AREVA

August 18, 2014
NRC:14:053

AREVA Inc. Response to Request for Public Comment on the Draft Regulatory Guides Supporting the Proposed 10 CFR 50.46c Performance-Based Emergency Core Cooling Systems Cladding Acceptance Criteria [DG–1261, "Conducting Periodic Testing for Breakaway Oxidation Behavior" (Docket ID NRC–2012–0041), DG–1262, "Testing for Post Quench Ductility" (Docket ID NRC–2012–0042), and DG–1263, "Establishing Analytical Limits for Zirconium-Based Alloy Cladding" (Docket ID NRC–2012–0043)]

Fig 5. Comparison of the α(O) layer obtained after 3270s at 1000℃ in SS-FH o r DS-IH conditions; (a) SEM images; (b) % α(O) layer deduced from SEM images analysis; (c) projected DS-FH α(O) layer distribution; (d) comparison between measured DS-IH and projected DS-FH

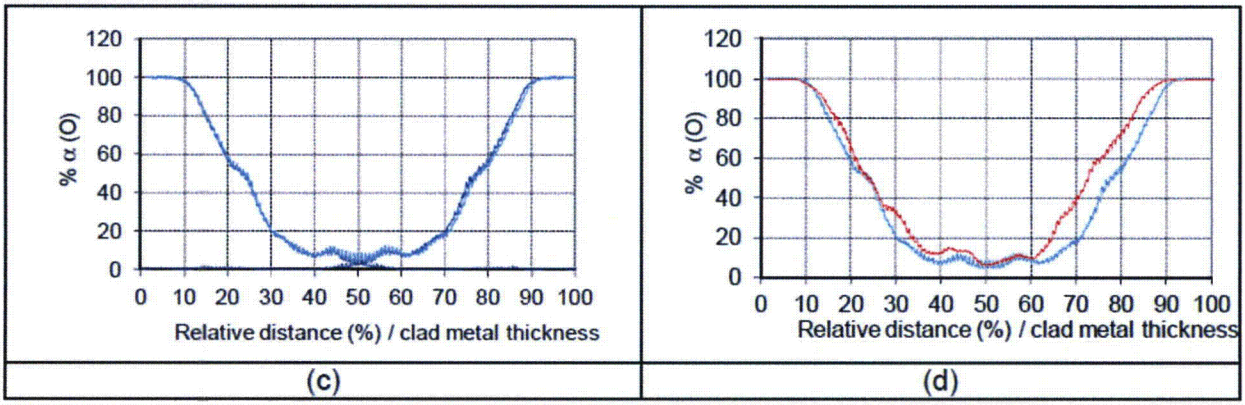
Basis for concern: As long as adequate temperature measurement and control (e.g., ramp rates) can be attained and postquench ductility is not affected by the method, the method of heating need not be specified. Previous challenges or preconceptions about the heating methods should not carry forward as prescriptions in regulatory guidance. Regardless of the heating methods, all must show thermal benchmarks.

Proposal: Recommendations for specific heating methods should be removed. Section 5.2 through 5.5 can be replaced with a single section focusing on adequate temperature control or the ability of a certain heating method to demonstrate results similar to those that are generally accepted.
